THE DISTRICT AT SOUTH BAY
SPECIFIC PLAN PROJECT

REVISED FINAL SUPPLEMENTAL ENVIRONMENTAL IMPACT REPORT

CITY OF CARSON
701 EAST CARSON STREET
CARSON, CALIFORNIA 90745

III. ADDITIONS AND CORRECTIONS TO THE DRAFT SEIR

Figure IV.B-6a
Conceptual Sign Locations — Option A

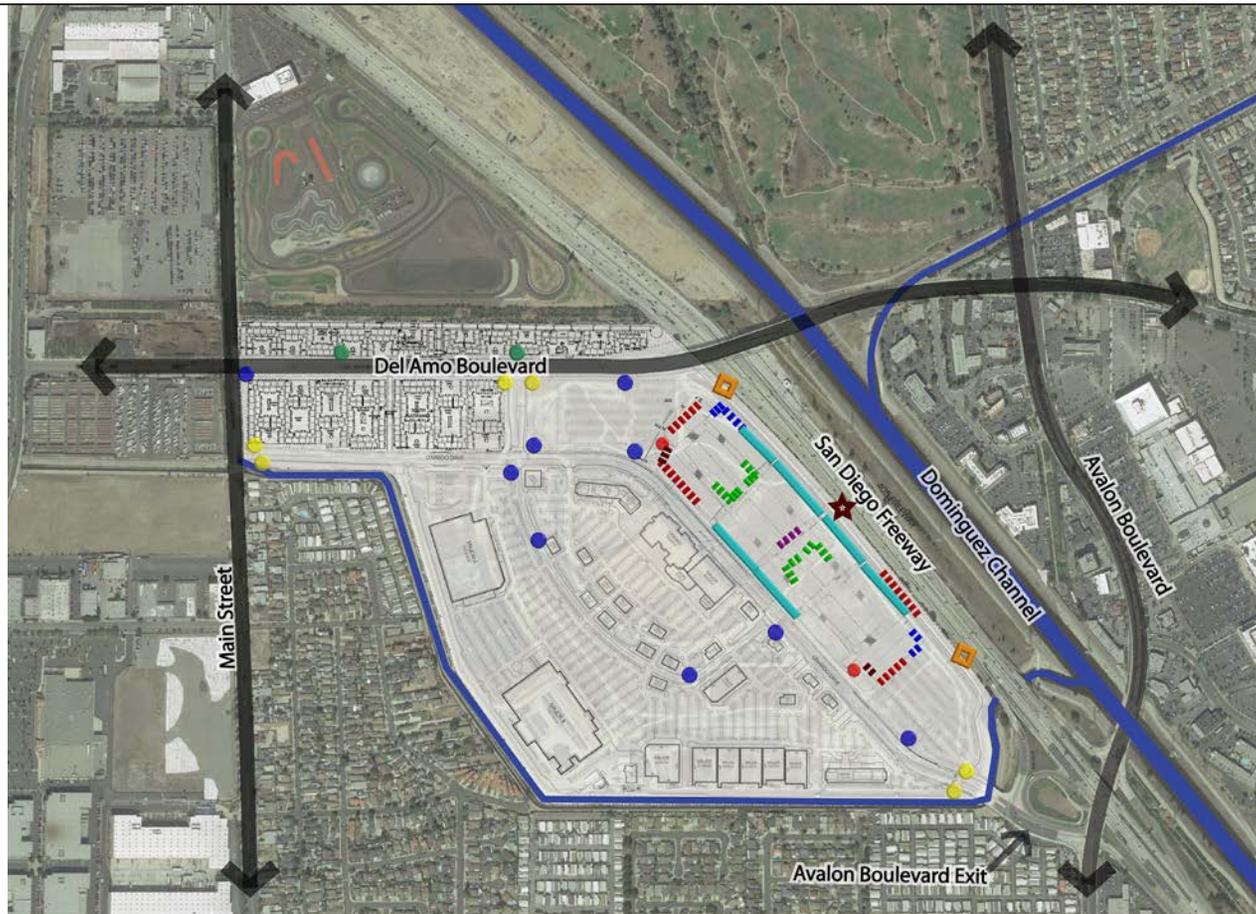
a. Volume I, page IV.B-18, Figure IV.B-6, Conceptual Sign Locations.

(See updated figures, below, titled “**Figure IV.B-6a, Conceptual Sign Locations—Option A**” and “**Figure IV.B-6b, Conceptual Sign Locations—Option B,**” which together replace Figure IV.B-6.)
